PREVOST

WARRANTY BULLETIN

WB16-02

DATE :	MAY 2016	SECTION :	06 - Electrical
EXPIRATION:	MAY 2018		
SUBJECT :	CHARGING SYSTEM IMPROVEMENT

FIGURE 7

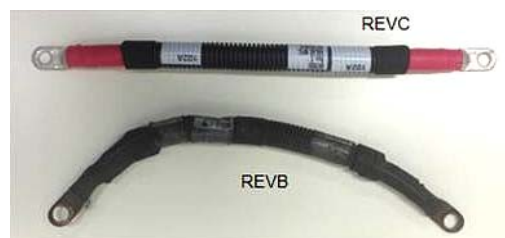
Rev.B diameter of the through hole is too large, reducing contact surface with the stud and the nut thus reducing electrical conductivity between the lug and the alternator stud (FIGURE 7).

6. Reinstall the jumper cable **#067835 revision C** included in kit #7770176 (FIGURE 5, FIGURE 6).

FIGURE 8

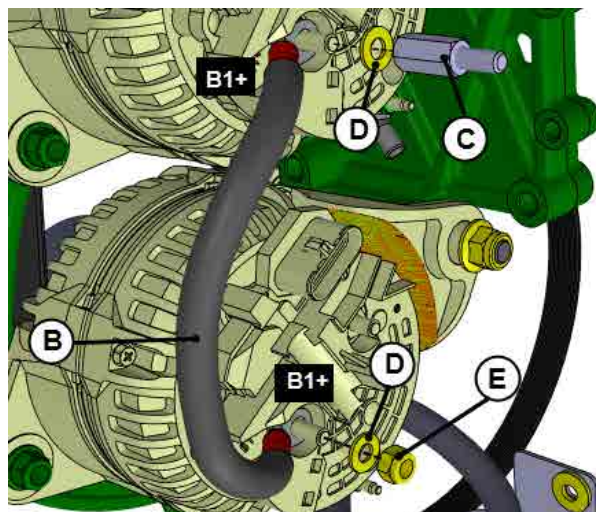
7. Reinstall appropriate jumper cable **B** (i.e. rev.C) with appropriate stud adapter. Refer to FIGURE 8.

B : JUMPER CABLE #067835 revision C

C : STUD ADAPTER #564590 torque: 10 lbf-ft

D: FLAT WASHER #5001341

E: NUT M8 #5001787 torque: 10 lbf-ft

FIGURE 10 : VECR

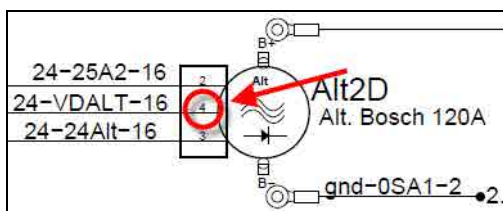
2.2 ALTERNATOR 24VD (DIRECT) ON PIN #4 CHANGED FOR 24VI (INDIRECT)
NOTE: this corrective measure may have already been performed on your vehicle

1. Inside rear electrical compartment (rear junction box), locate VECR module (FIGURE 10).

FIGURE 14

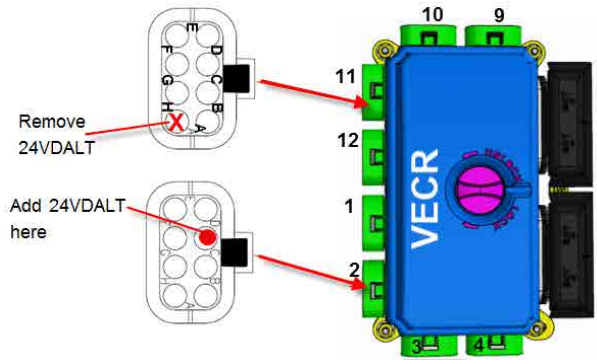
- Relocate wire 24VDALT to cavity **C** of connector no.2 (red) on the harness.

Cavity **C** of connector no.2 should be available. This branch of the circuit will be protected by 10A fuse F64 (see FIGURE 16 below).

IMPORTANT NOTE: If required, extend wire 24VDALT using 16 AWG red electrical wire in order to reach connector no.2.

FIGURE 16 : WIRING DIAGRAM PAGE 5.1

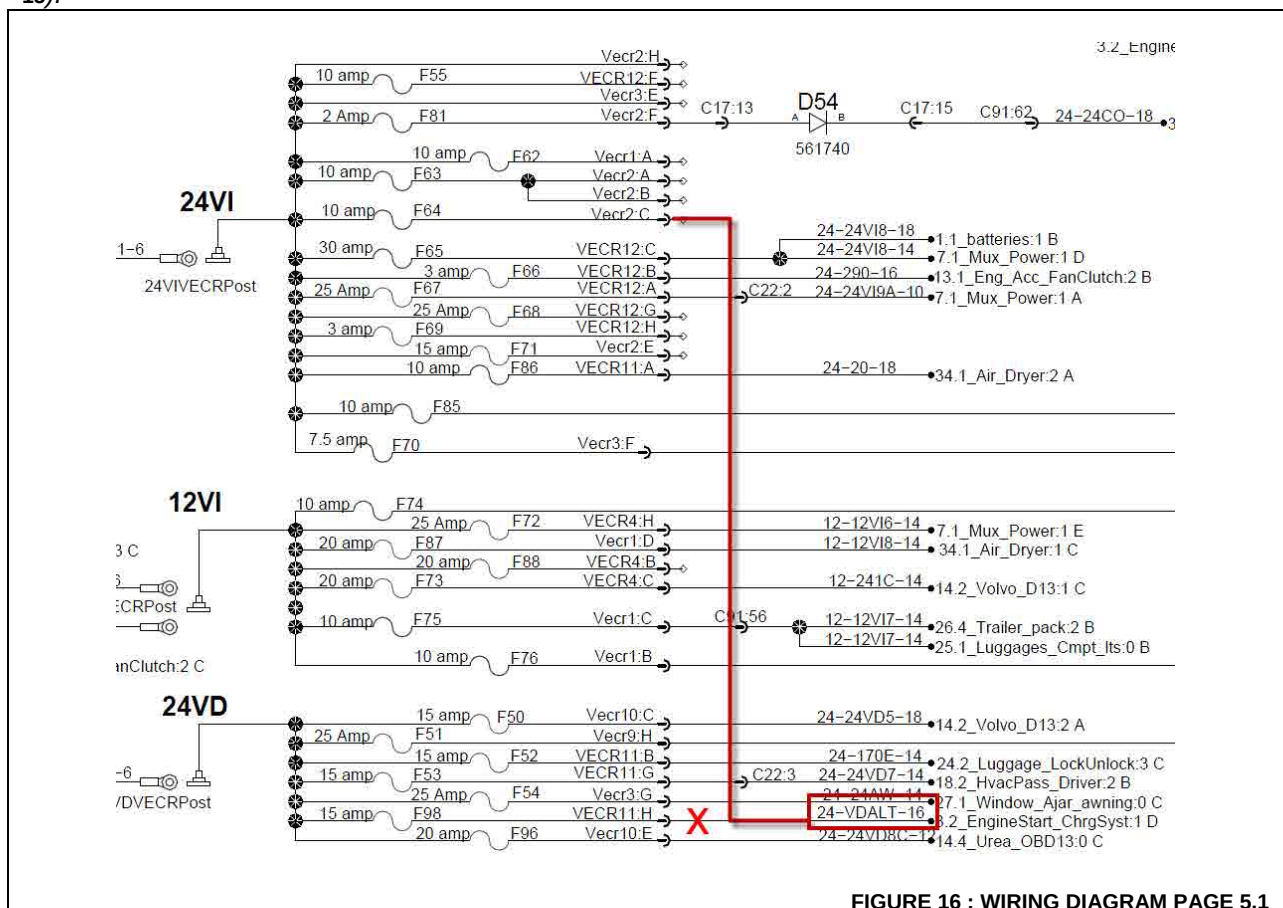
Should cavity C not be available, refer to your vehicle wiring diagram page 5.1 to select another free cavity protected by a 10A or 15A fuse (see FIGURE 16 for reference).

FIGURE 20

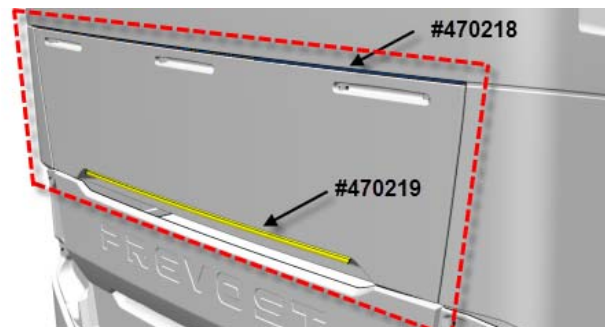
2. Clean dirt on the lower part of the **exhaust aftertreatment system ATS** access hatch as well as the area located right above the ATS access hatch (FIGURE 20). It is very important to install the drip edge on a clean surface to assure water tightness.

NOTE: FIGURE 20 shows where the drip edges will be installed.

FIGURE 26

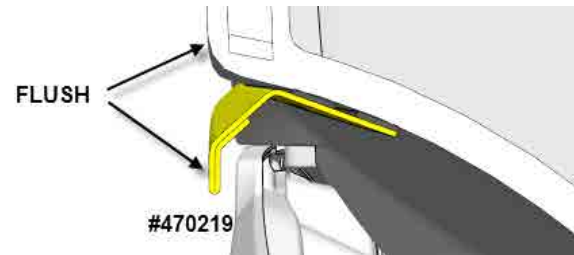
The front face of the drip edge must be flush with the surface above. The goal is to prevent water from dripping on the inner side of the engine compartment door.

FIGURE 40

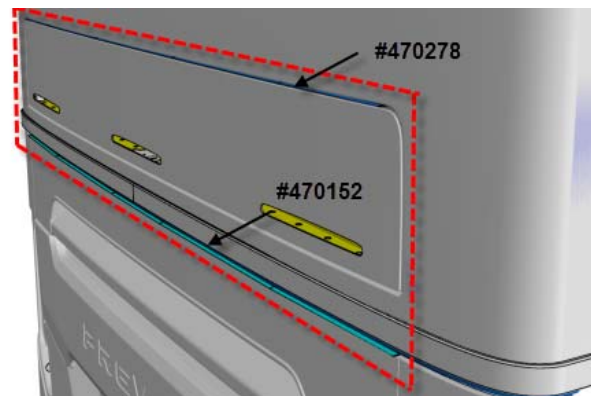
2. See on FIGURE 40 where each drip edge will be positioned. The drip edges will be fastened on the vehicle body, **not on** the ATS access hatch.

FIGURE 48

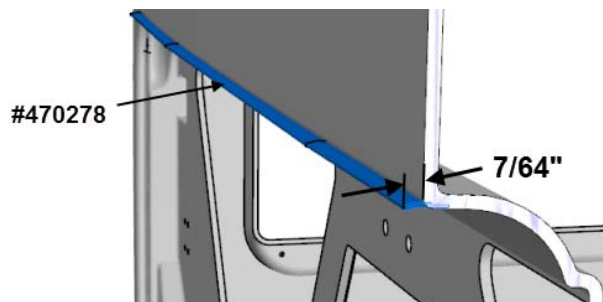
The drip edge should extend past the panel surface by **7/64** of an inch. The goal is to prevent water/rain from dripping on the inner side of the SCR access hatch.

IMPORTANT NOTE: The drip edge must not be stuck on the vehicle body except in the middle area where the drip edge cannot be fastened with rivets. In this particular case, peel back the protective layer on the adhesive foam tape and stick to the surface.

No rivets are used to fasten the middle of the drip edge because the rivet head will interfere with the upper edge of the ATS access hatch.

FIGURE 52

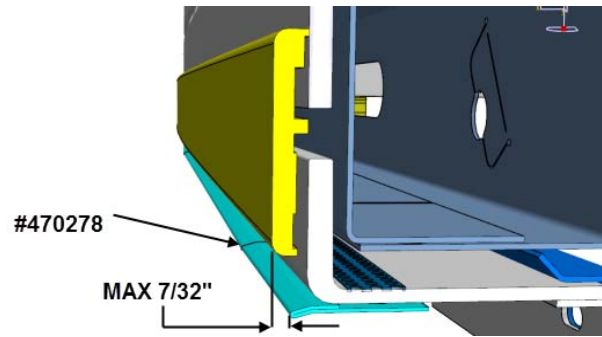
The drip edge should be shifted not more than 7/32" from the surface of the molding located above it (FIGURE 52). The goal is to prevent water from dripping on the inner side of the engine compartment door.
